Office Action Summary	Application No. 10/520,325	Applicant(s) WOEHR, KEVIN	
	Examiner MICHAEL J. ANDERSON	Art Unit 3767

DETAILED ACTION

Claims 1-4 and 9 are rejected under 35 U.S.C. 103(a) as being unpatentable over Bialecki (US 6,652,486) in view of Tauschinski (US 4,387,879).

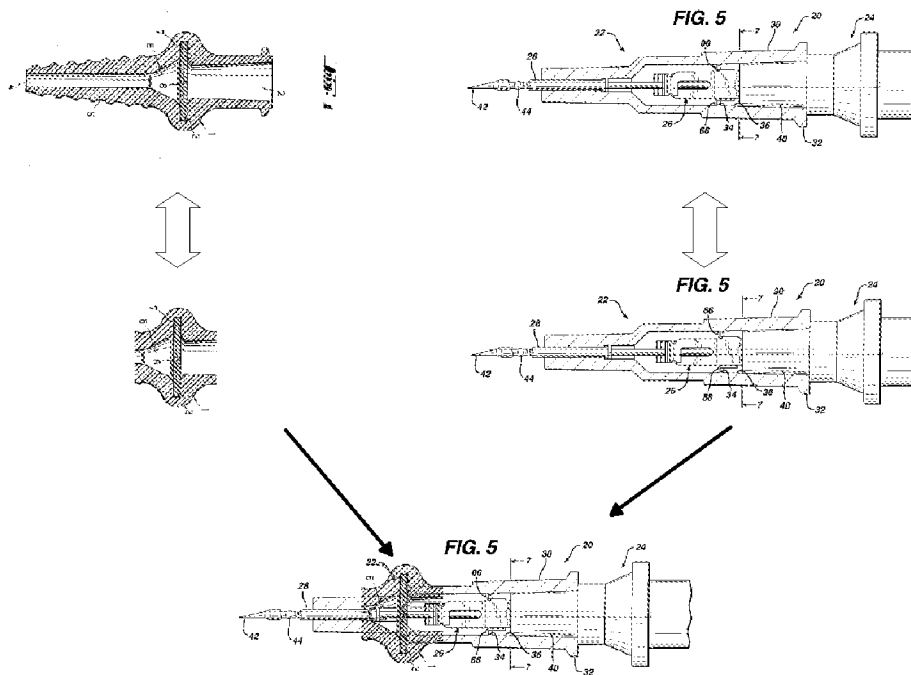
To address applicants' arguments with regards to claim 1, note the Examiners "combo device" (see figures below) is not as depicted by applicants arguments on 6/25/2009 regarding the "combo device" figure on page 13.

In response to applicant's argument that the combined components of Bialecki (figure 1 above) and Tauschinski (figure 5 above), are not compatible, the fact that applicant has recognized another advantage which would flow naturally from following the suggestion of the prior art cannot be the basis for patentability when the differences would otherwise be obvious. See *Ex parte Obiaya*, 227 USPQ 58, 60 (Bd. Pat. App. & Inter. 1985).
